Schaerer Coffee Club Software version 2.8.3

Description of changes

The following changes have been made since software version 2.6.1:

1. 30g brewing unit

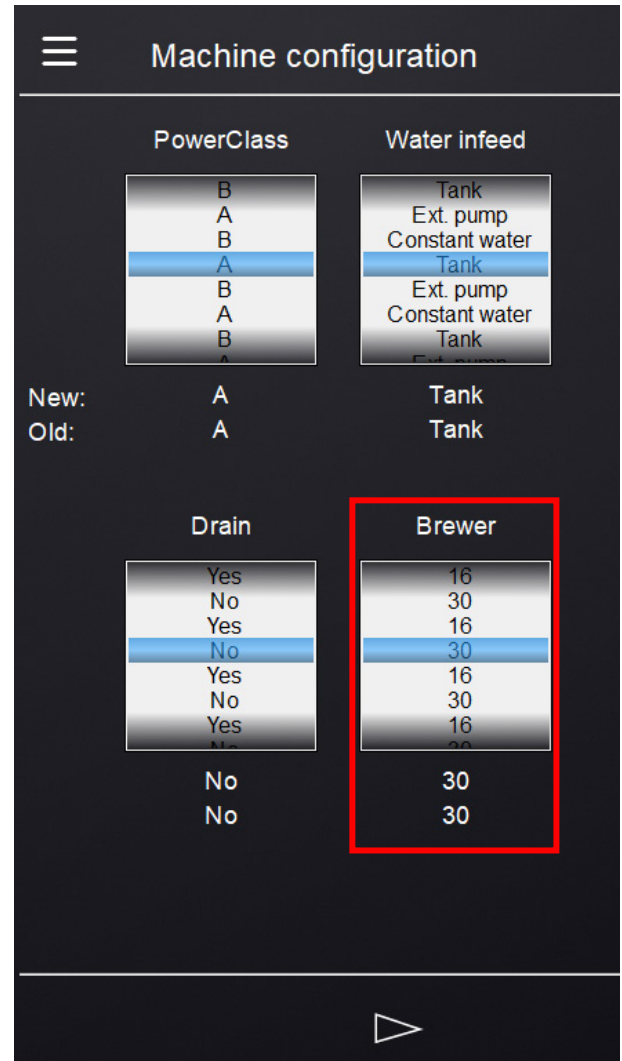
With the introduction of the new software version, an additional machine configuration is available when ordering new machines **ex works**.

In addition to the standard configuration with the 16g brewing unit, it is now possible to configure the machine with a 30g brewing unit.

The brewer motor mount differs between machines with 16g and 30g brewing units. Changing the brewer type on machines in the field is not intended.

The brewing unit used must be set in the machine configuration:

System > **Machine configuration**
